15 October 2013  
Ref 13158

**DEVELOPMENT APPLICATION NUMBER 65/2003**  
**PROPOSED EXPANSION OF SUPERMARKET AND PUBLIC CAR PARKING AREA**  
**TRAFFIC MATTERS**

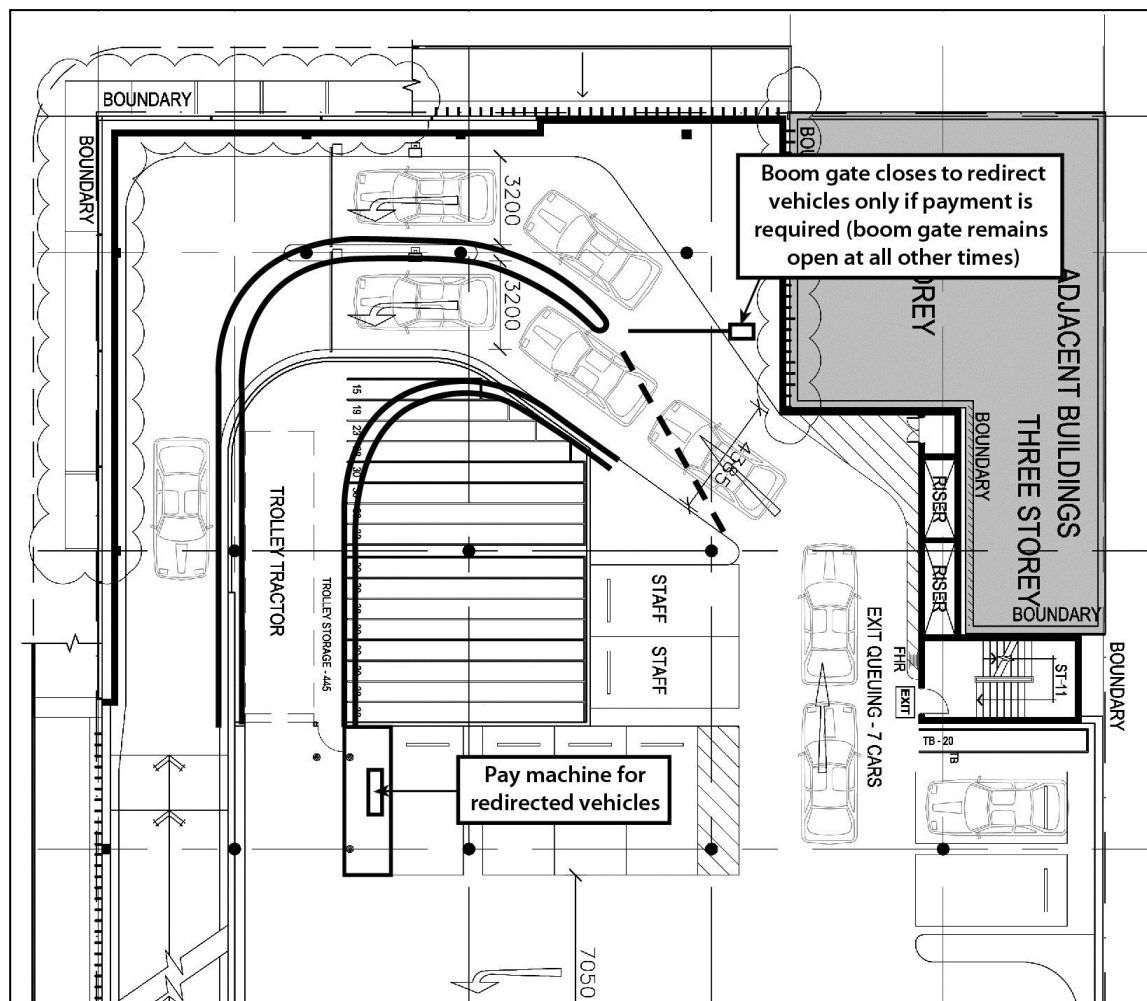
The capacity analysis based on 300 vehicles per hour per boom gate is not relevant, particularly in circumstances where access to the second boom gate could be blocked by just two cars waiting at the first boom gate. However, *Clause 3.4 Queuing Areas* of *AS2890.1 – 2004* requires **a minimum queuing length of 3 cars per lane**.

In addition, for a car park with 296 spaces *Table 3.3* of *AS2890.1 – 2004* requires the following minimum queue length of 18 cars (or two lanes with 9 cars each) as set out below:

First 100 cars; 3% of capacity:	9 cars
Second 100 cars; 2% of capacity:	6 cars
Additional Cars; 1% of capacity:	3 cars
<b>Total Queuing Length Required:</b>	<b>18 cars</b>

The proposed queuing area at the exit boom gates has the capacity to accommodate only 7 cars before circulation around car park level 1 could be blocked, and/or entry into the car park could also be blocked.

The implementation of a *ticketless* boom gate/payment system (of the same type used at the Woolworths Lane Cove car park) would alleviate these concerns. A *ticketless* boom gate system uses conventional number plate recognition software to identify a vehicle which has overstayed the time limit and redirects those vehicles to a payment machine by *closing* the boom gate. The exit boom gate therefore remains open at all other times, thereby allowing for the free flow of traffic in/out of the car park without *any* queuing.

It is therefore recommended that condition of development consent be imposed requiring the implementation of a *ticketless* parking system to control the operation of the proposed public car parking area.
